Subject: Arkansas Nuclear One - Unit 1
Docket No. 50-313
License No. DPR-51
Arkansas Nuclear One - Unit 1 - Reply To Request For Additional Information
(RAI) RE: Improved Technical Specification Section 1.0, "Use and Application,"
2.0, "Safety Limits," 3.1, "Reactivity Control Systems," and 3.2, "Power
Distribution Limits" (TAC No. MA8082)

NRC Comment Resolution
ITS Section 1.0: "Use and Application"

IMPROVED TECHNICAL SPECIFICATIONS SUBMITTAL

02/06/01 Supplement
(Sections 1.0, 2.0, 3.1, and 3.2)

Figure 3.1.9-1

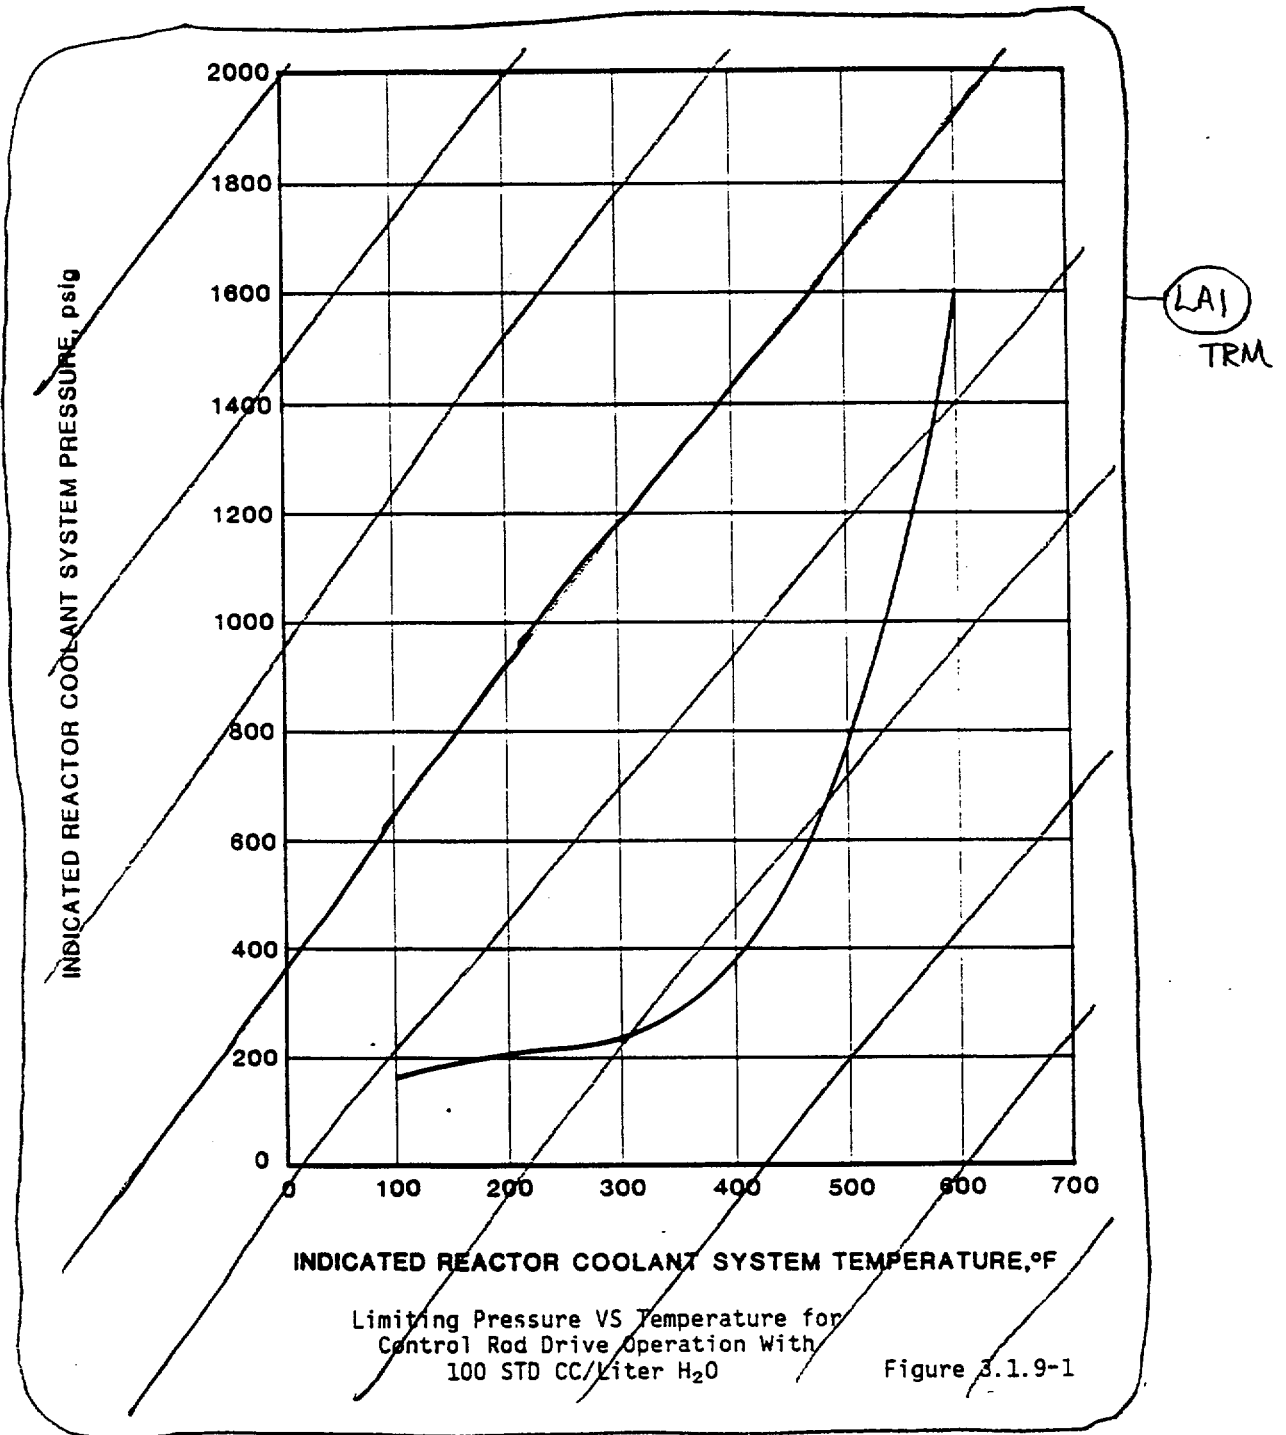
The CTS dissolved gases concentration requirements are moved to the TRM. The CTS required actions, if the gas concentrations are not restored to within limits within 24 hours, are to be in Hot Shutdown within the next 6 hours and to be in Cold Shutdown within the next 30 hours. These CTS required actions are not moved to the TRM because a shutdown is required to perform the remaining required action of checking the vessel level instrument vent for the accumulation of undissolved gases. Comment: By deleting the shutdown required actions results in there being no time frame in which to perform the vent check. What does ANO-1 perceive the appropriate actions and time frames to be? What process did ANO-1 use to determine that these actions were to be deleted?

- Response**
- 1) 3.1DOC-L14 has been revised to provide additional details concerning the proposed TRM Required Actions and Completions Times in the event dissolved gas concentration is not within limits.
 - 2) CTS markup page 32 has been revised to show that the action requiring restoration of parameters to within limits within 24 hours has been relocated to the TRM as discussed in 3.1DOC-L14 and 3.1DOC-LA1.
-
